Subject: Description of Permissive Change

Model Name: WR1-IPEX

FCC ID: 2ANDL-WR1

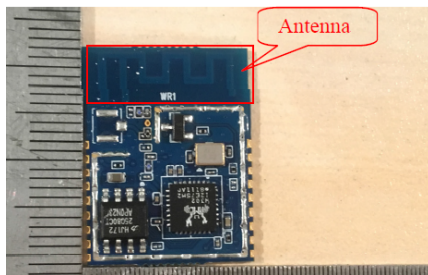
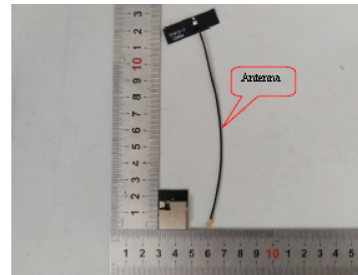
We apply for a Class II permission Change,the device is identical to the previously certified except for the changes as below for details:

1. Add the model name "WR1-IPEX" ,WR1 still remain the same (as original).
2. The antenna type is different: add FPC antenna.
